Subject: **Request for Modification for Section 404 Regional General Permit No. 201902350 and Section 401 Water Quality Certification** for the Interstate 485 (I-485) improvements from I-77 to US 74 (Independence Boulevard), Mecklenburg County, Division 10, TIP I-5507. Debit \$570.00 from WBS 43609.3.2.

The purpose of this letter is to request modification of the United States Army Corps of Engineers (USACE) Section 404 Regional General Permit 201902350 (RGP 50) and associated North Carolina Division of Water Resources (NCDWR) Section 401 Water Quality Certification for the above referenced project.

**PERMIT DRAWING
SHEET 1 OF 115**

Revised August 2021
PERMIT DRAWING
SHEET 55 OF 115

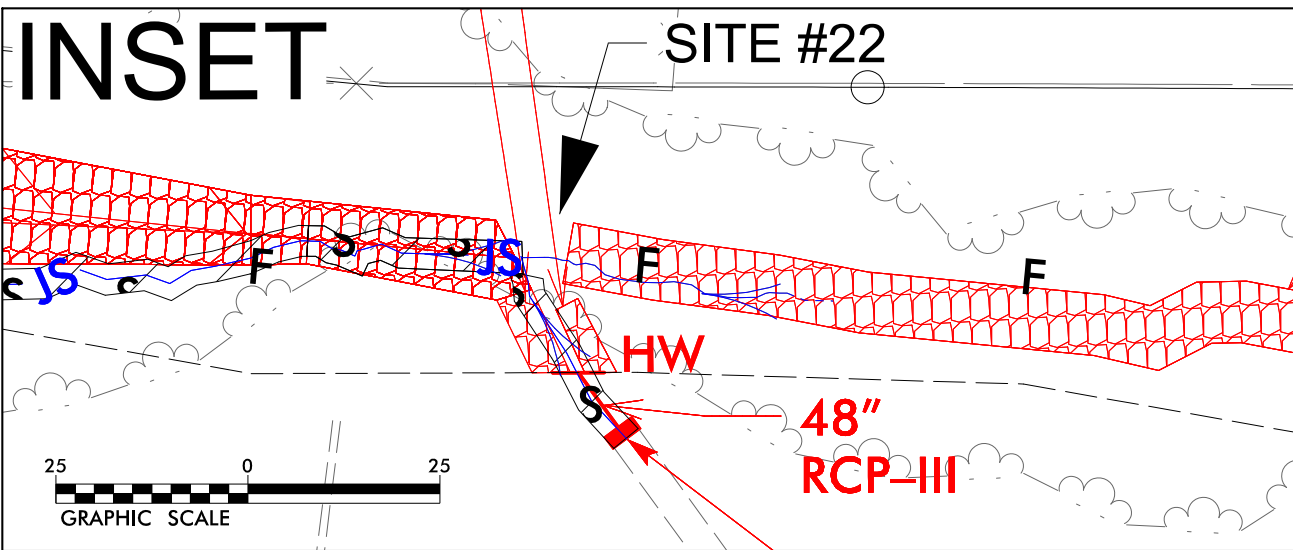
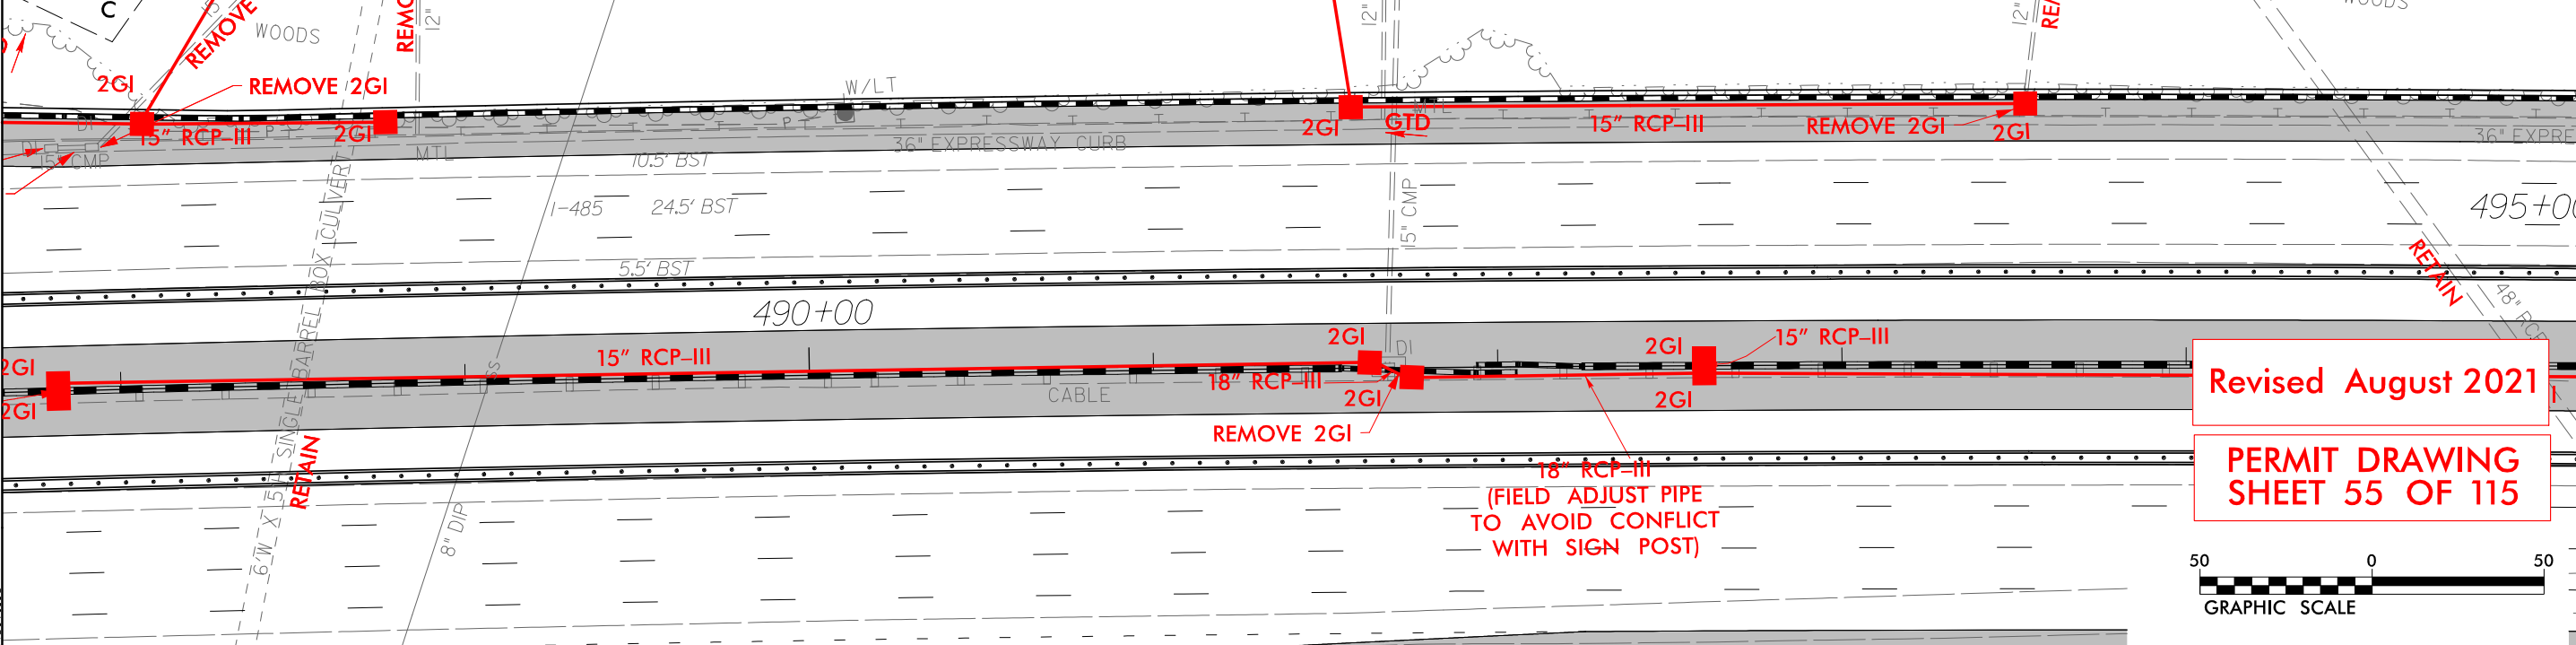
During construction at this site, it was discovered the invert elevation used in the original design for the existing 48" RCP outfall did not accurately reflect field conditions. In the proposed design, the channel change for stream SG has been extended farther upstream to accommodate drainage from the 48" RCP extension. This 48" RCP extension has been installed at the correct pipe invert elevation based on field conditions and the length of the culvert extension will remain that same as previously permitted. Impacts for the previous permitted design included 140 linear feet of permanent stream channel impacts, including 129 linear feet from channel change and 11 linear feet from culvert extension, 24 linear feet of permanent bank stabilization impacts, and 49 linear feet of temporary stream impacts to stream SG. The proposed design will result in a total of 169 linear feet of permanent stream channel impacts, including 158 linear feet due to the channel change and 11 linear feet from the culvert extension, 24 linear feet of permanent stream bank stabilization impacts, and 20 linear feet of temporary stream impacts. The proposed design will result in an increase in permanent stream channel impacts of 29 linear feet and a decrease in temporary stream impacts of 29 linear feet. The design change will not result in any additional permanent bank stabilization impacts.
